**COUNTY OF MONROE  
DEPARTMENT OF TRANSPORTATION**

**ADDENDUM NO. 1  
TO THE  
CONSTRUCTION SPECIFICATIONS AND RELATED DOCUMENTS  
FOR  
PAUL ROAD – FISHER ROAD CORRIDOR IMPROVEMENTS  
Capital Improvement Project No. 1433  
NYS DOT P.I.N. 4754.24**

December 5, 2012

TRANSITION FOR PAVEMENT AT DRIVEWAYS

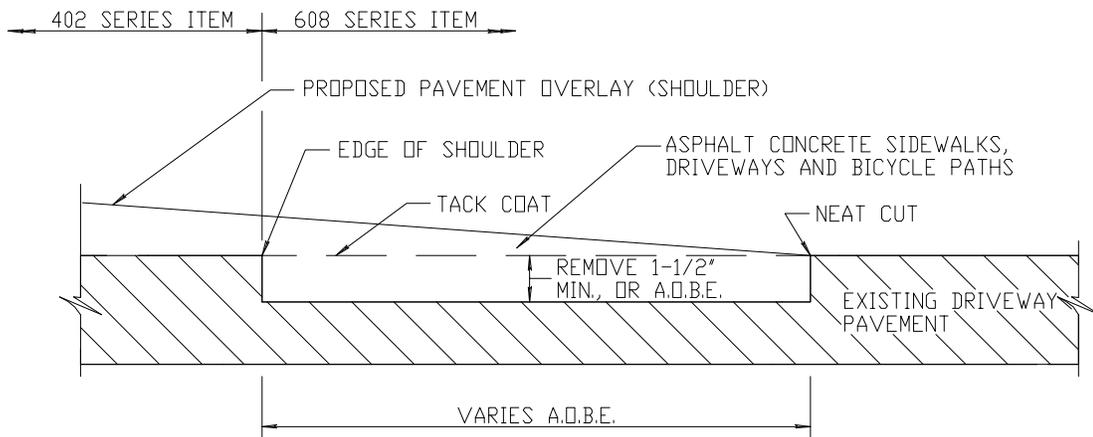
1. In the Contract Plans sheet 23 of 96, **ADD** the attached “Transition for Pavement at Driveways” detail (Page ADD 1-48).
2. In the Contract Plans sheet 24 of 96, on the detail for “Storm Sewer Trench in Paved Area”, **DELETE** note ‘4’ in its entirety.
